ZFSWA2-63DR+ PCN Report

AN-80-011

As a result of obsolescence of the original dice used in MMIC inside, the re-design effort includes the use of a new set of dice in existing package maintaining existing case style. The replacement MMIC has been judged by Mini-Circuits Engineering as a suitable replacement for the existing ZFSWA2-63DR+.

COMPARISON PERFORMANCE CURVES^a:

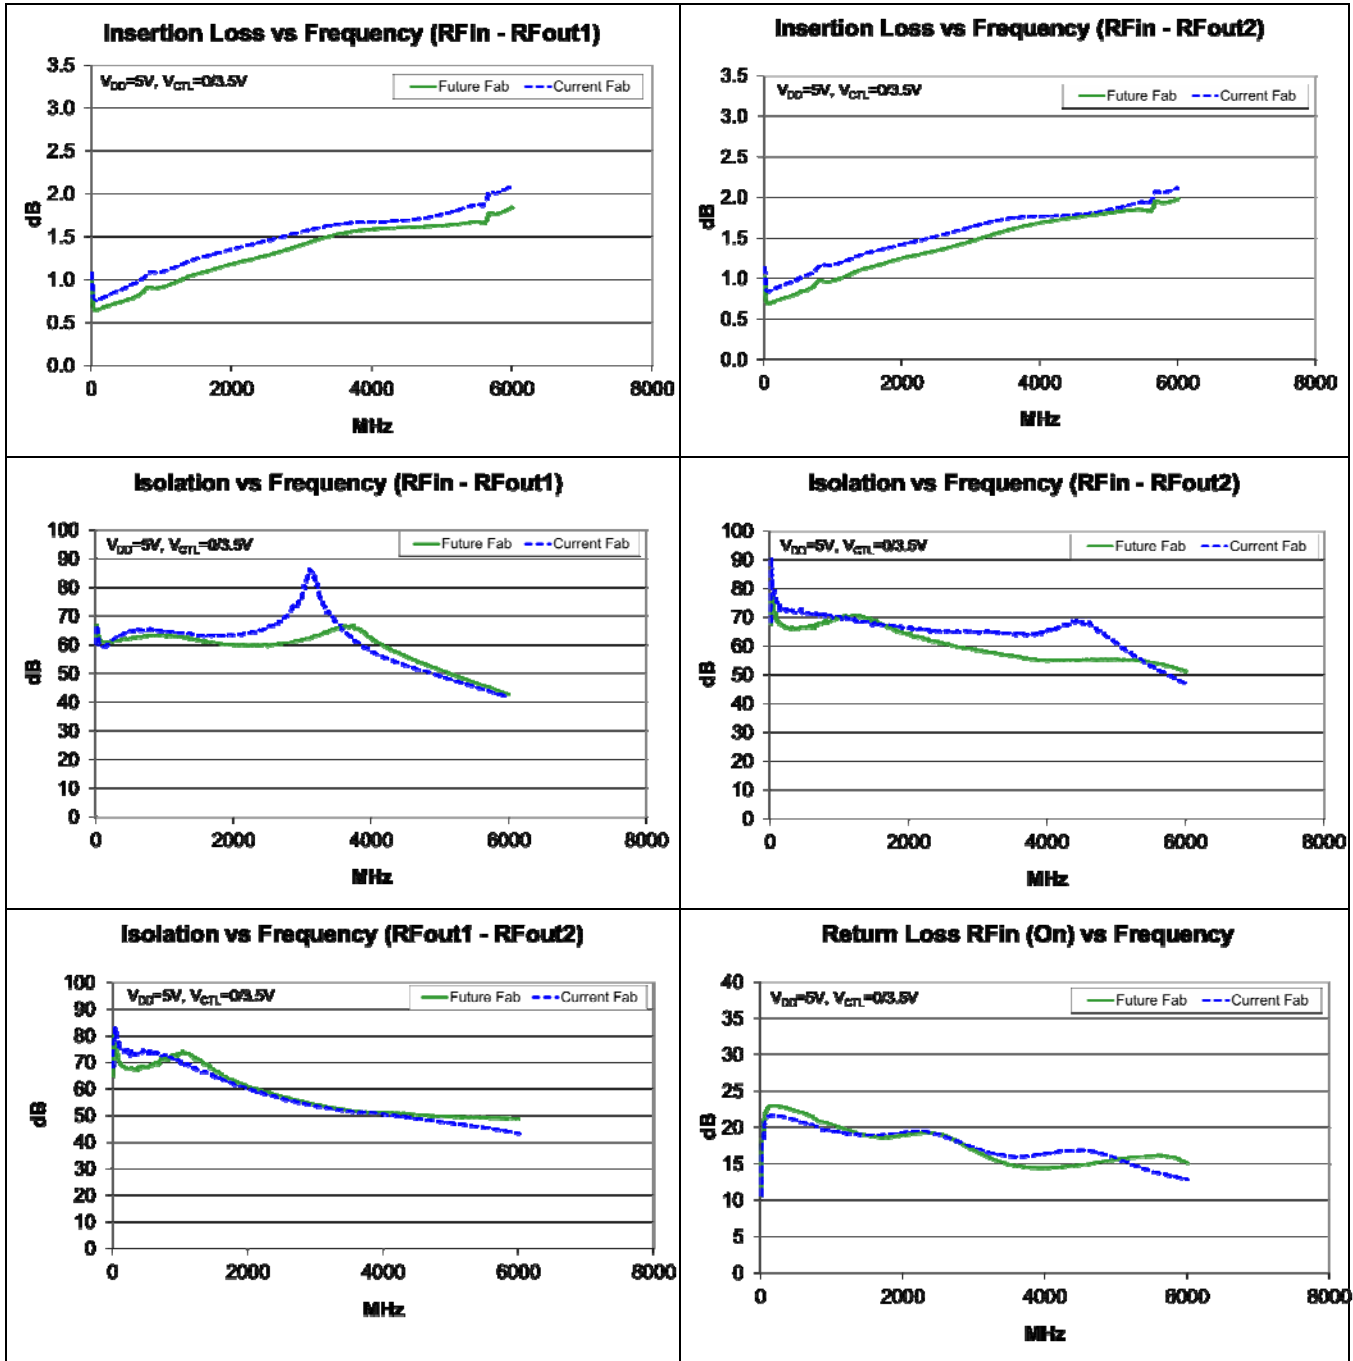
2) TYPICAL PERFORMANCE COMPARISON ON CONNECTORIZED UNIT ^a: T_{AMB}=25°C, V_{DD}=5V

3) TYPICAL PERFORMANCE COMPARISON OF MMIC INSIDE: T_{AMB}=25°C, V_{DD}=5V
